Access Compliance Report

Public Rights-of-Way

(Curb Ramps)

Intersection ID: 42476	Main Street: SIR_CHARLES_PL	Cross Street: HARRISON_STEEL_DR	Location: SE
ADA ID: 618DB843226E	Ramp Type: PerpDiag	Initial Pass/Fail: Fail	Overall Compliance: No
Severity Score: 13.75			
Codes/Mitigation Info/Possible Solution		Field Measurements/Component Compliance

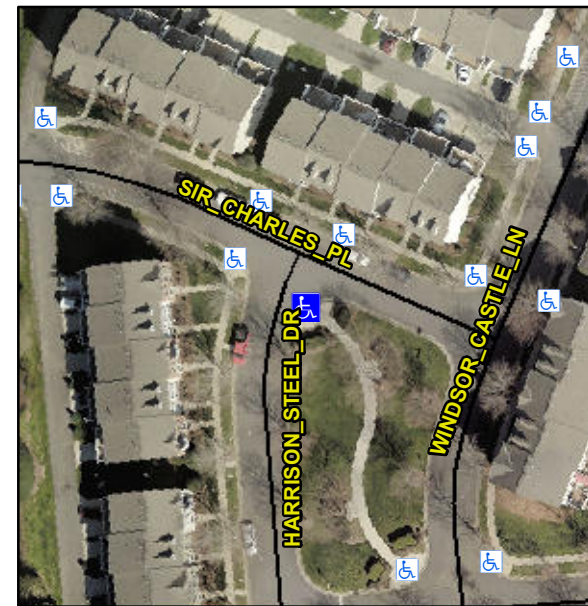
R304.2.2, R304.5.3

Compliance	Description	Data	Compliance	Description	Data
N/A	Ramp Length (in)	106.0	No	Ramp Slope (%)	8.6
Yes	Ramp Width (in)	48.0	No	Ramp XSlope (%)	3.8
N/A	Flare Type LT	N/A	N/A	Flare Type RT	N/A
N/A	Flare Slope LT (%)	N/A	N/A	Flare Slope RT (%)	N/A
N/A	Flare Traversable LT?	N/A	N/A	Flare Traversable RT?	N/A
N/A	Landing Length (in)	N/A	N/A	DWS Provided?	N/A
N/A	Landing Width (in)	N/A	N/A	DWS Contrast?	N/A
N/A	Landing Slope (%)	N/A	N/A	DWS Length (in)	N/A
N/A	Landing X Slope (%)	N/A	N/A	DWS Full Width?	N/A
N/A	Landing Curb? (Y/N)	N/A	N/A	DWS Offset (in)	N/A
N/A	Shared Landing?	N/A			
N/A	Gutter Ponding?	N/A	N/A	Gutter Slope (%)	N/A
N/A	Gutter Lip Ht (in)	N/A	N/A	Gutter X Slope (%)	N/A
N/A	Painted X Walk1?	No	N/A	Painted X Walk2?	No
	X Walk 1 Direction	To NE		X Walk 2 Direction	To NW
N/A	X Walk 1 Width (in)	N/A	N/A	X Walk 2 Width (in)	N/A
	X Walk 1 Slope (%)	4.7		X Walk 2 Slope (%)	4.1
	X Walk 1 X Slope (%)	1.7		X Walk 2 X Slope (%)	2.0

N/A	Ramp inside XWalk1?	N/A	N/A	Ramp inside XWalk2?	N/A
	Road Slope (%)	2.4	N/A	Clear Space?	N/A
	Road X Slope (%)	2.2	N/A	Clear Space to XWalk (in)	N/A
N/A	Any Obstructions?	N/A	N/A	Storm Grate/Utility Hazard?	N/A
	Obstruction Type			Storm Grate/Utility Type	
		N/A			N/A
			Yes	Surface Condition? (G/P)	Good

Remove & Replace Curb Ramp With Two New Directional Ramps or Equivalent.
